Addendum No.: 4

Date of Addendum: June 17, 2020

Willard Diloreto Parking Garage
Paul Manafort Sr. Drive
New Britain, CT
CF – RC – 402

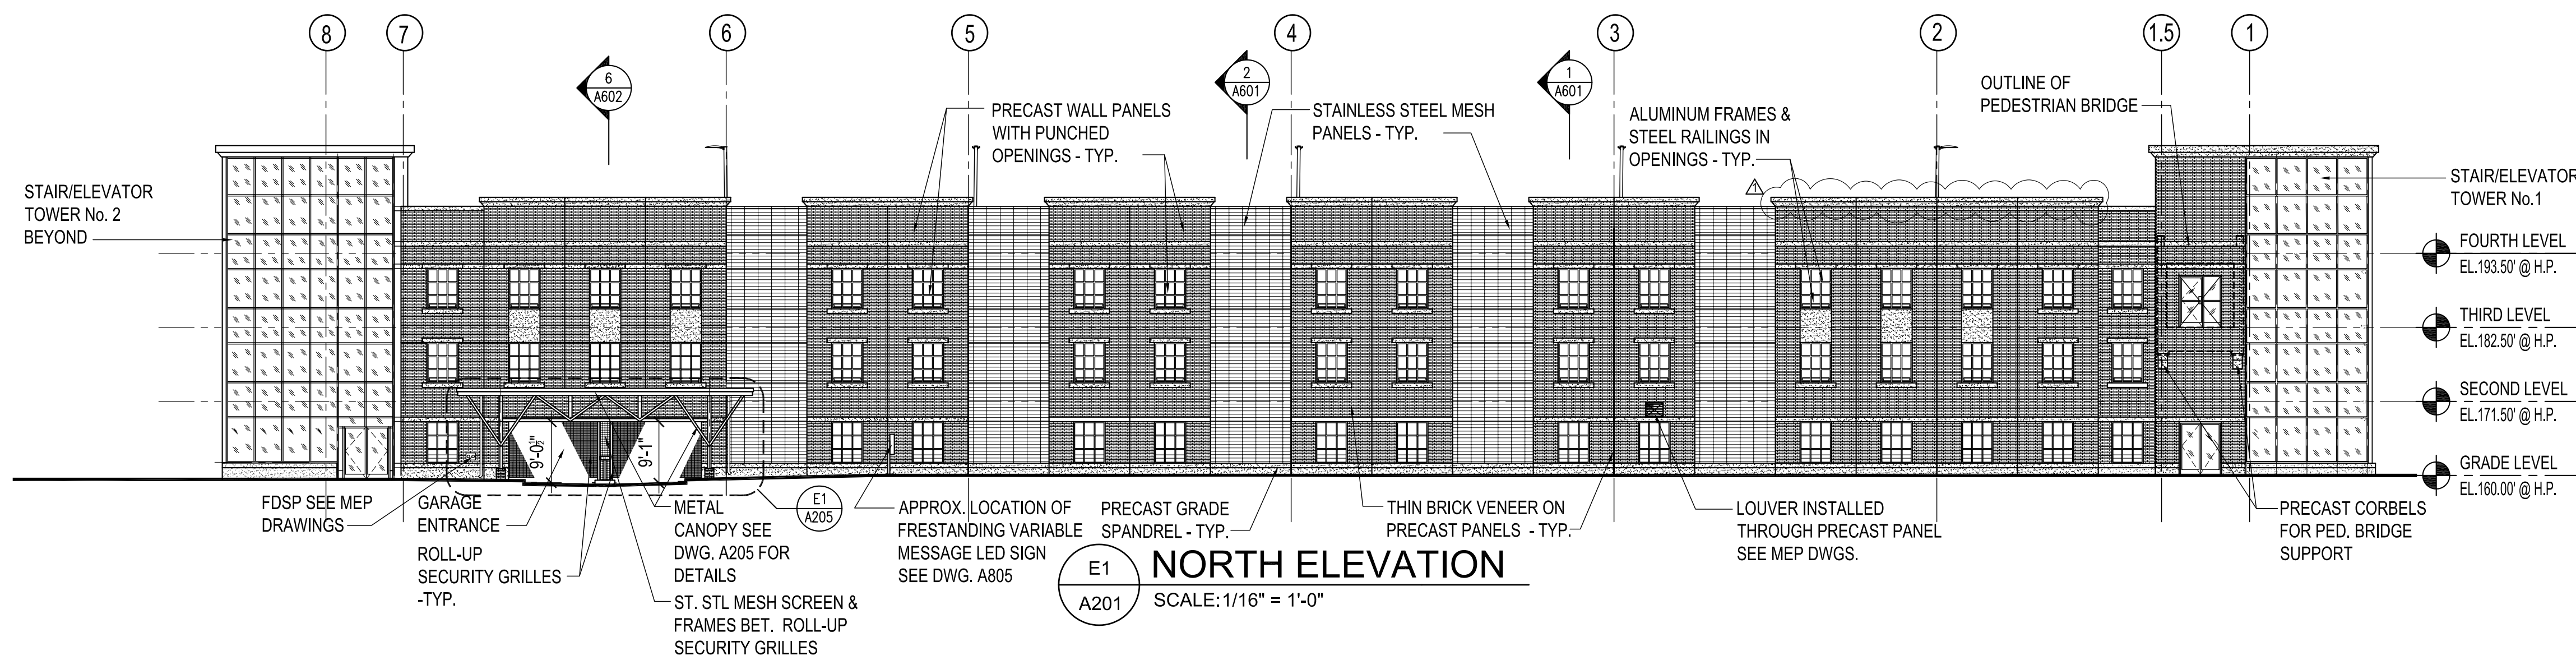
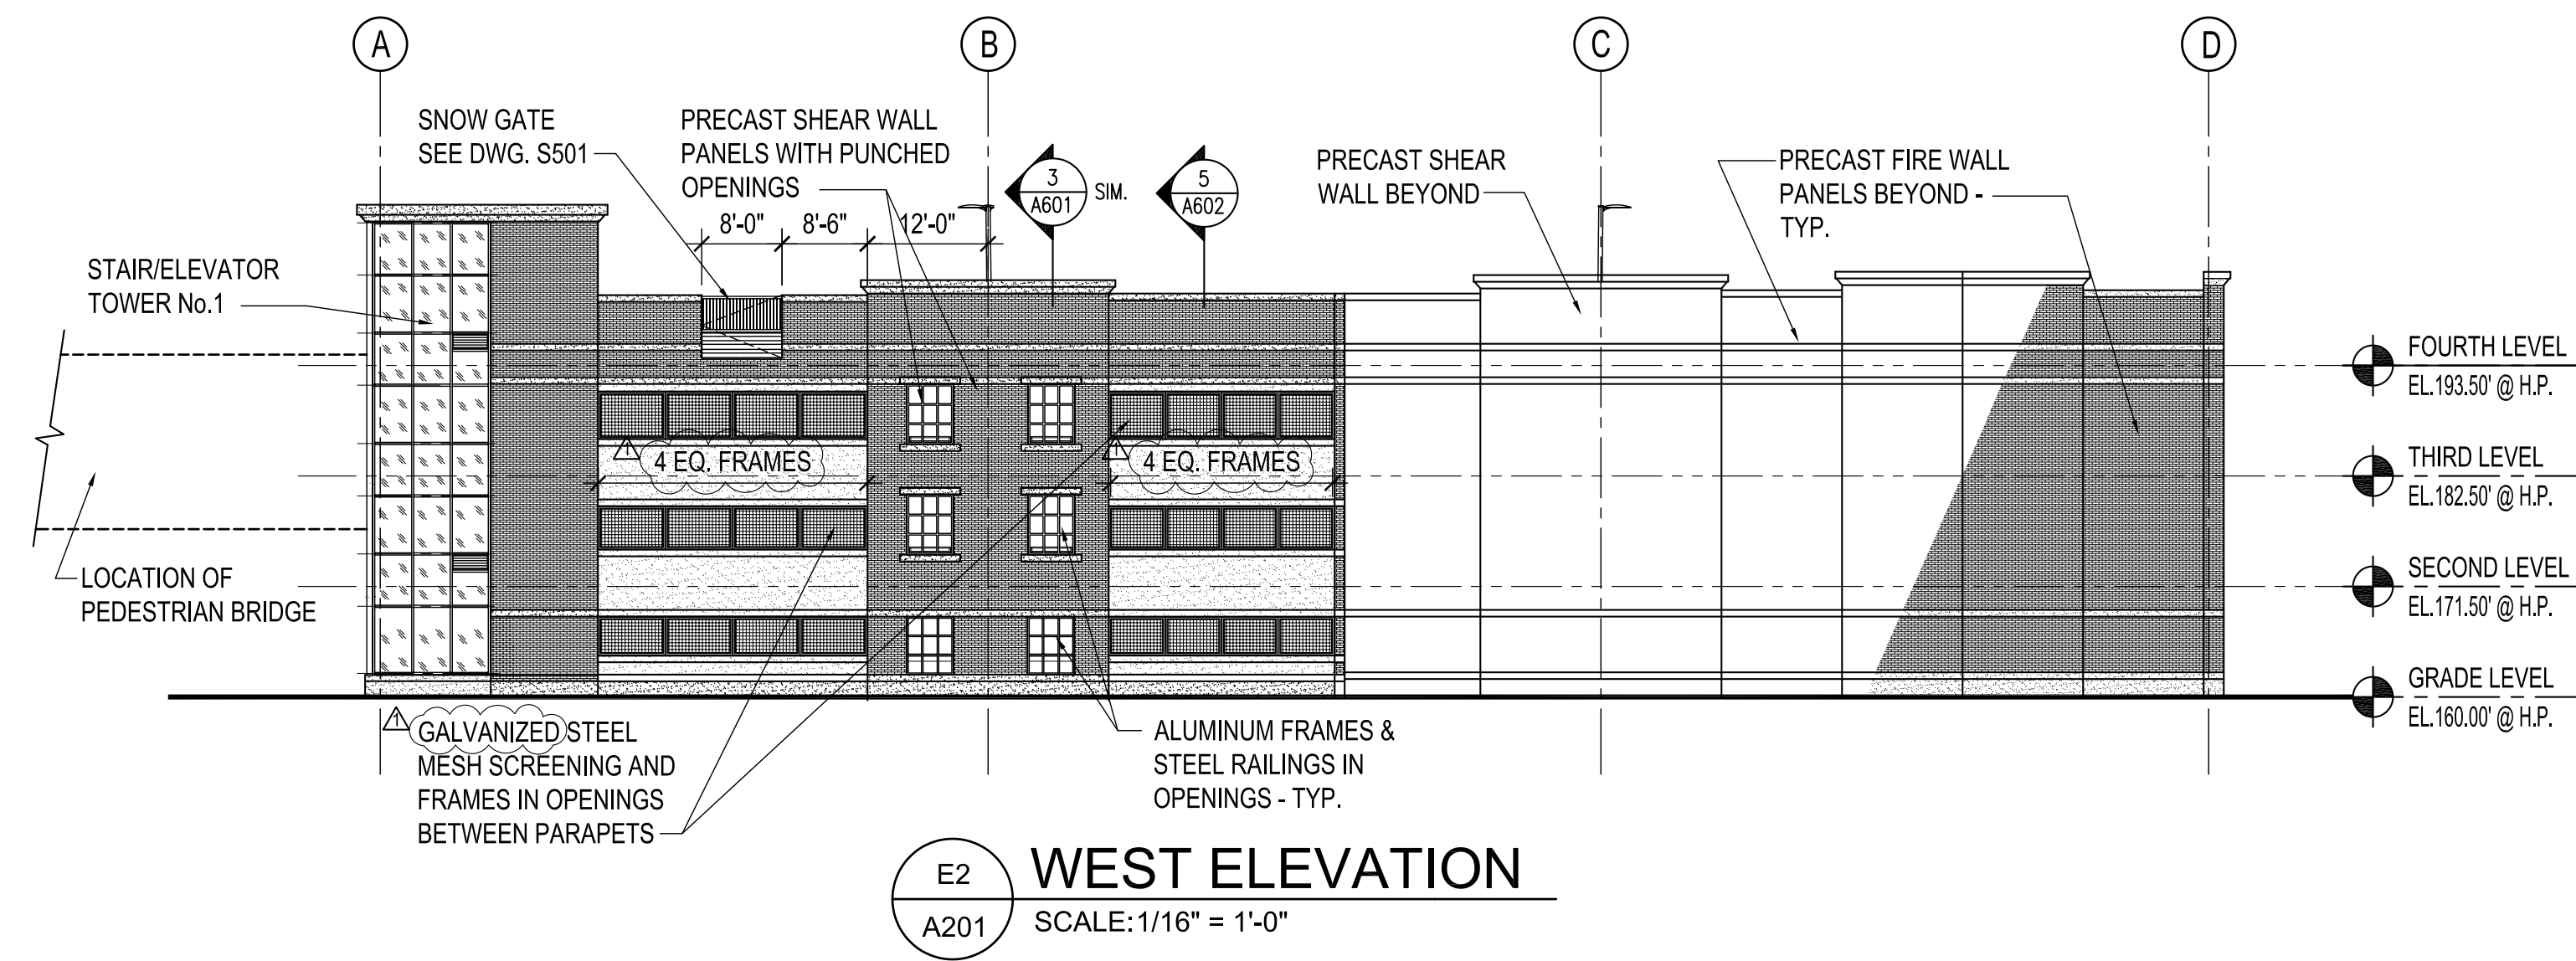
Question: Drawing A201 - The typical cornice shown on all of the Building Elevation drawings is

represented with two (2) horizontal bands; except for one location on the North Elevation. Please review the cornice at the North Elevation for the wall panels centered on Grid line 2. The Elevation Drawing shows three (3) horizontal bands for the cornice at this location. Is there a special cornice required at the top of the precast wall panels, centered on grid 2 If yes, please provide section detail for the cornice at this location?

Question: Elevation E2 / A201 calls for stainless mesh screen and frames between parapet openings. We assume specification 05 50 00 2.1 K. Stainless Steel Mesh Panels is in reference to these openings. Please confirm.

Answer: See revised drawing A201. The cornice in question should be the same as the other top of wall cornices.

Answer: See revised drawings A201 and A602 and revised specification section 05 50 00. Mesh panels are to be galvanized and not stainless steel.

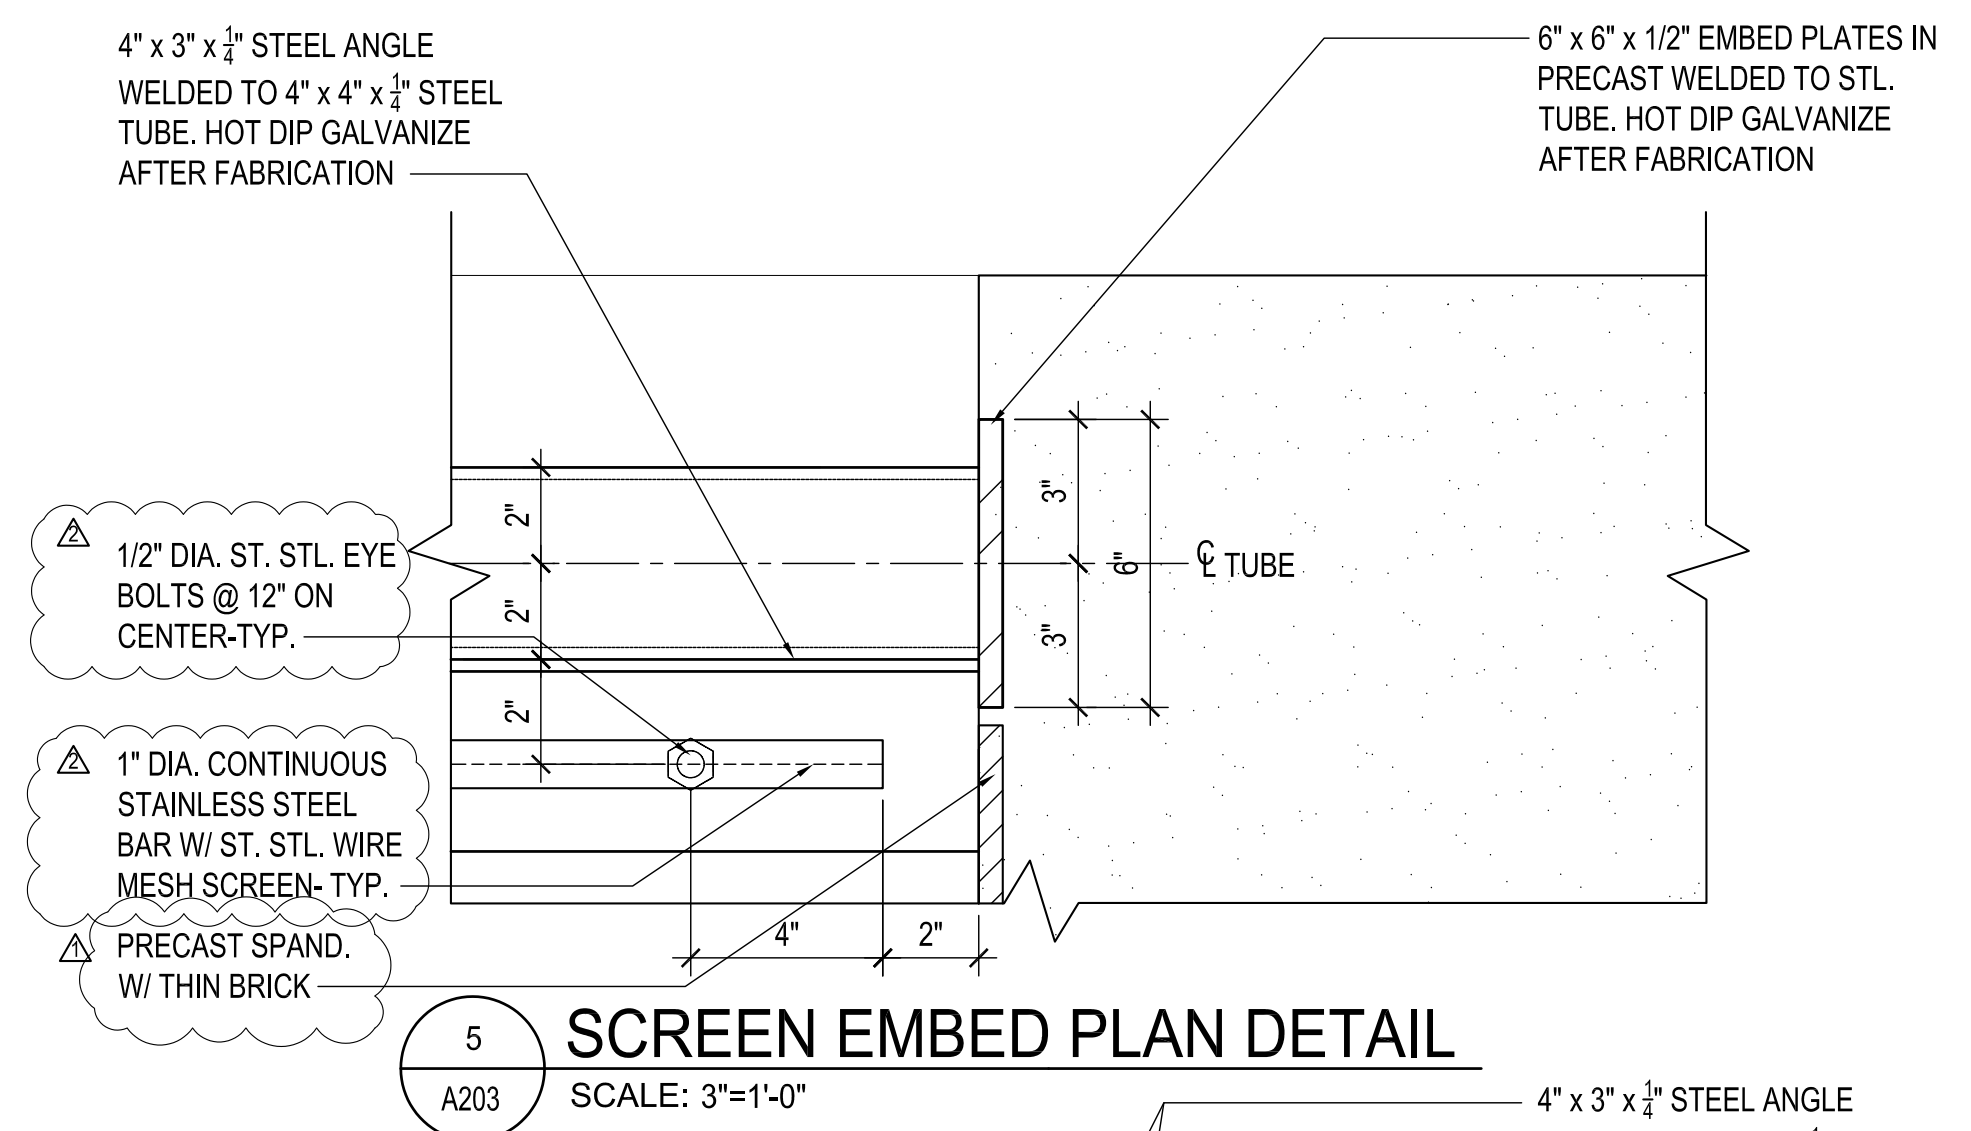
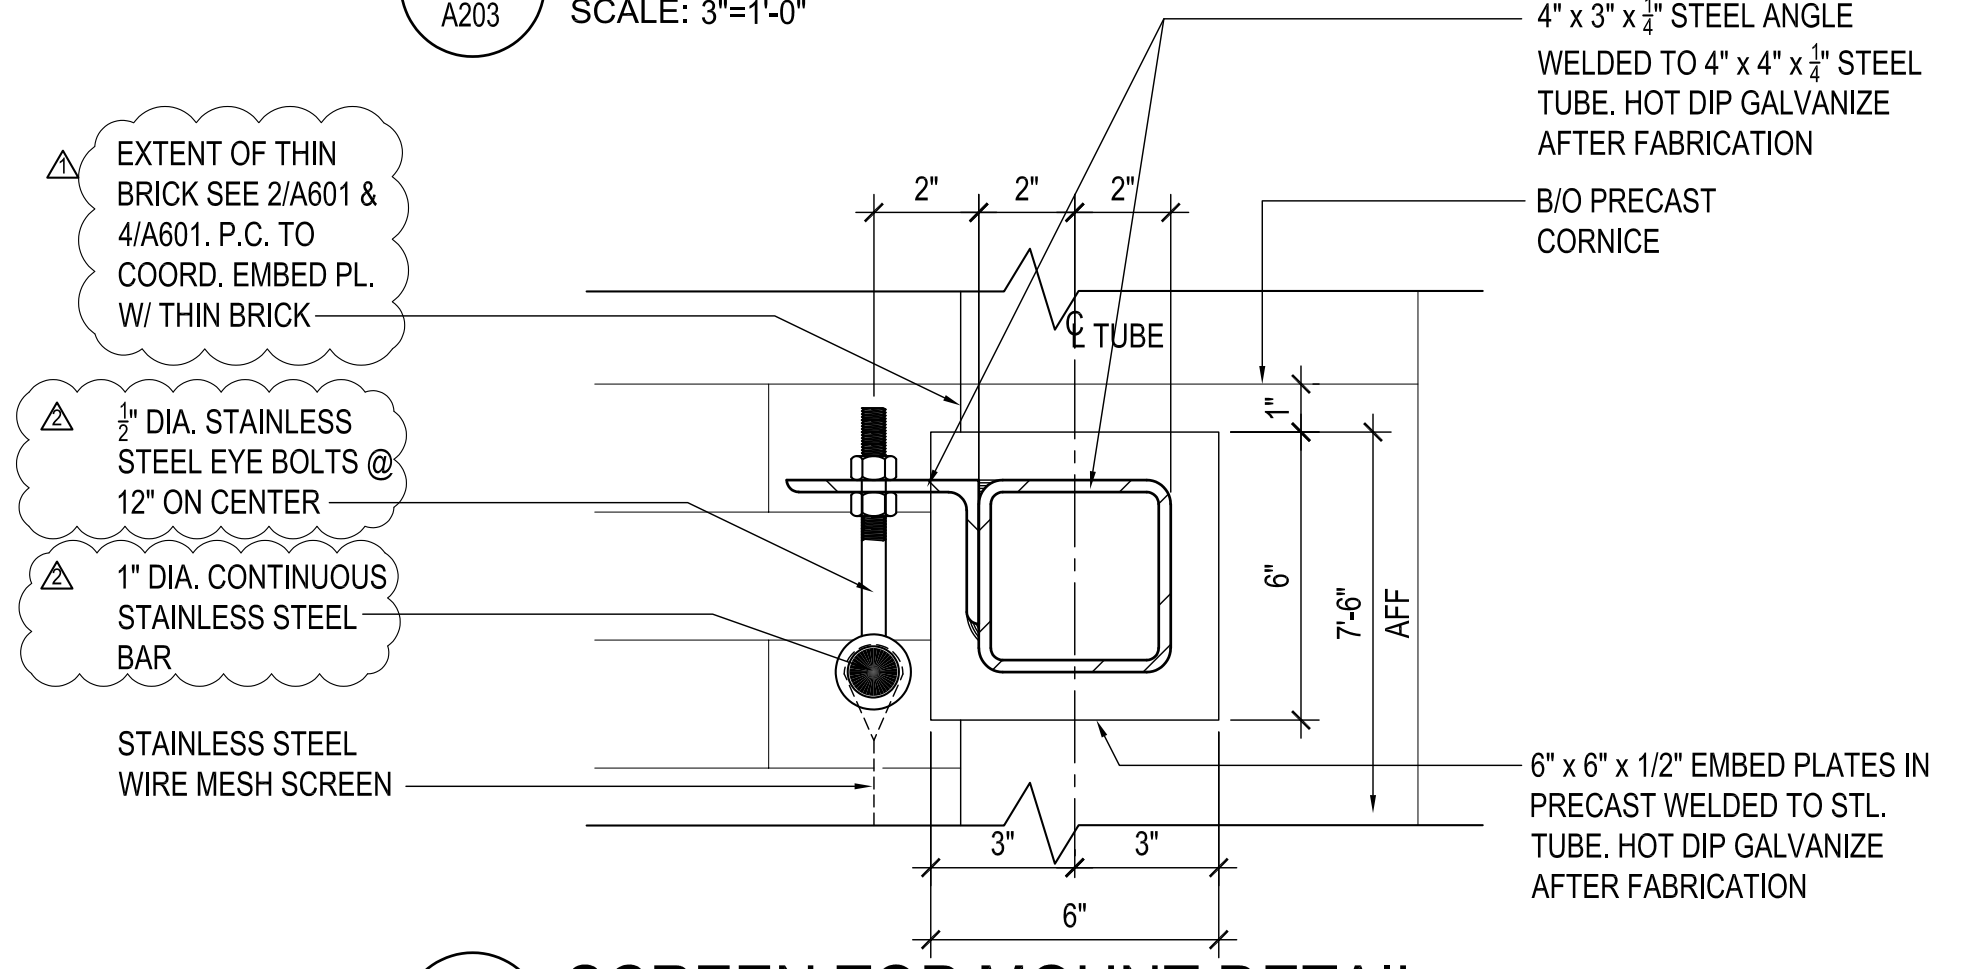
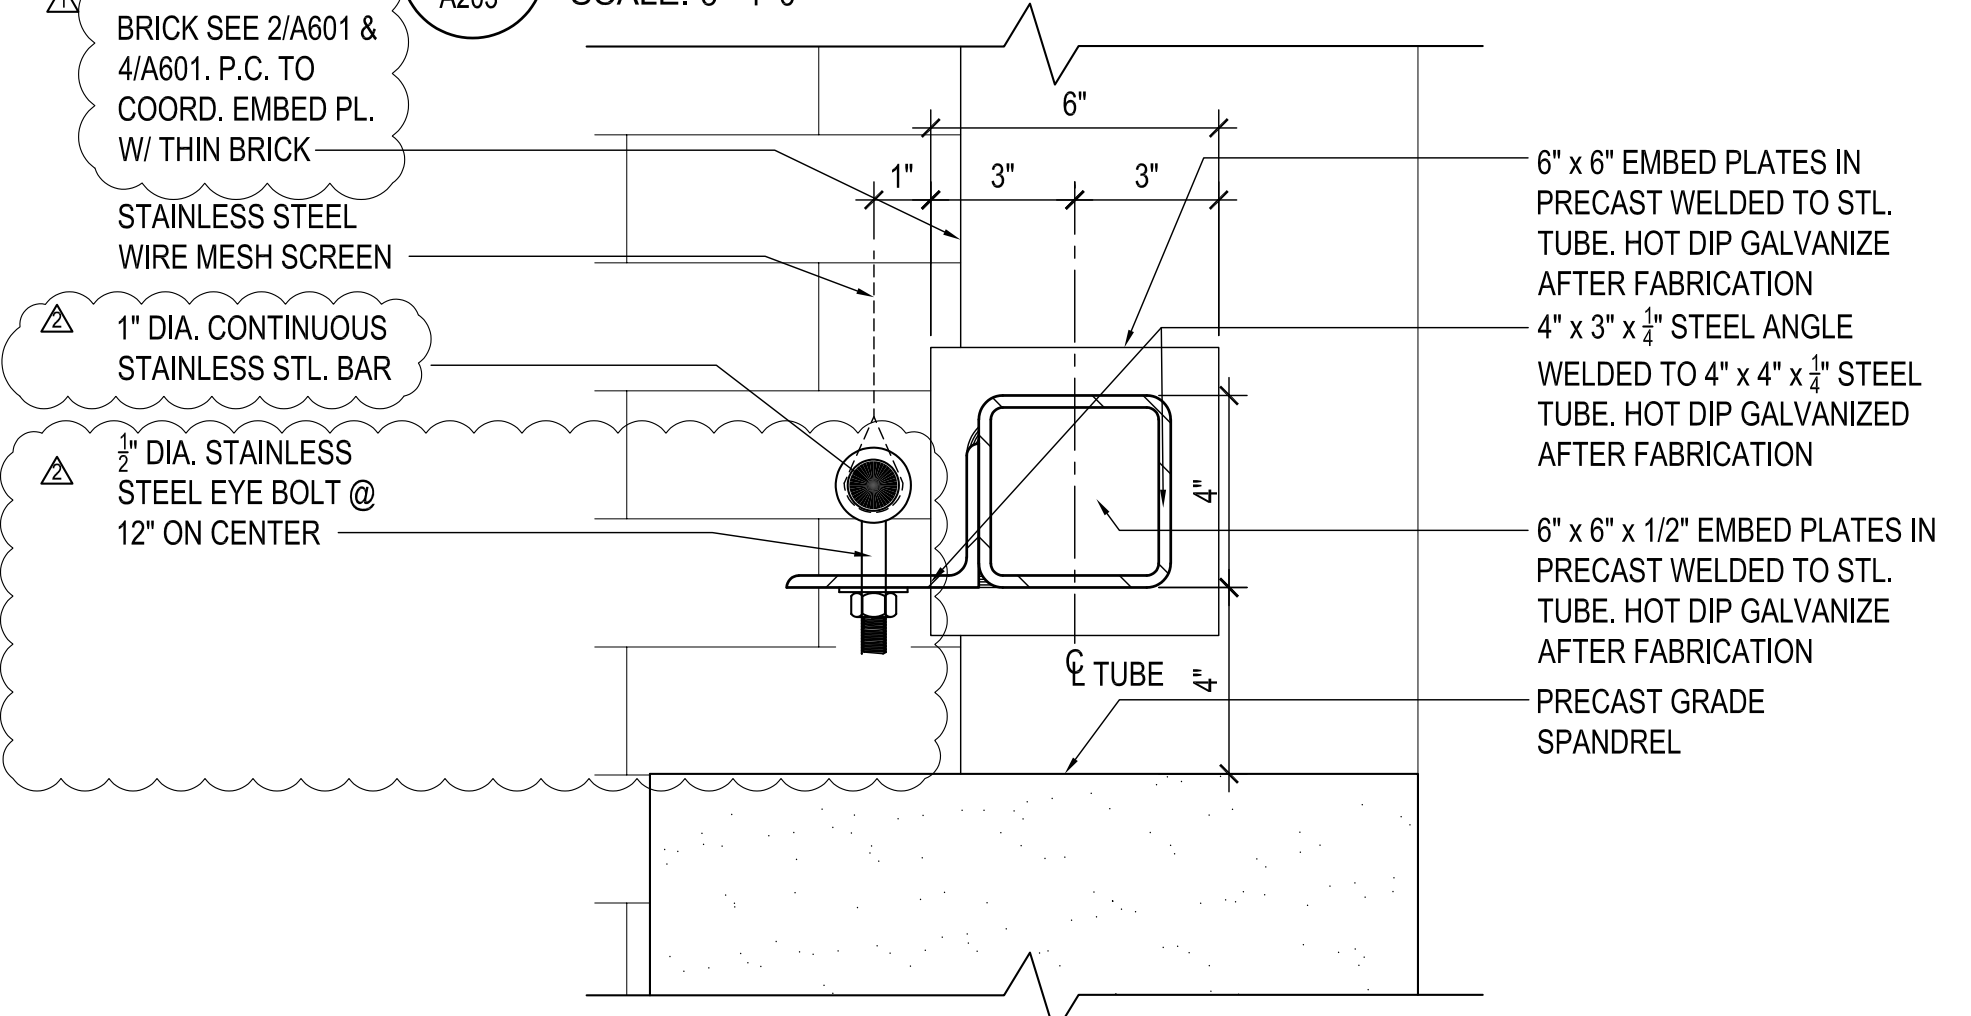
Question: Drawing A203 is calling for Galvanized continuous bars and attachments at the mesh screens. Due to the tendency to wear and rust over time, would Stainless 316L be recommended in lieu of Galvanized? See attached.

Answer: See revised drawing A203. Details have been revised to include all stainless steel hardware for the mesh screen.
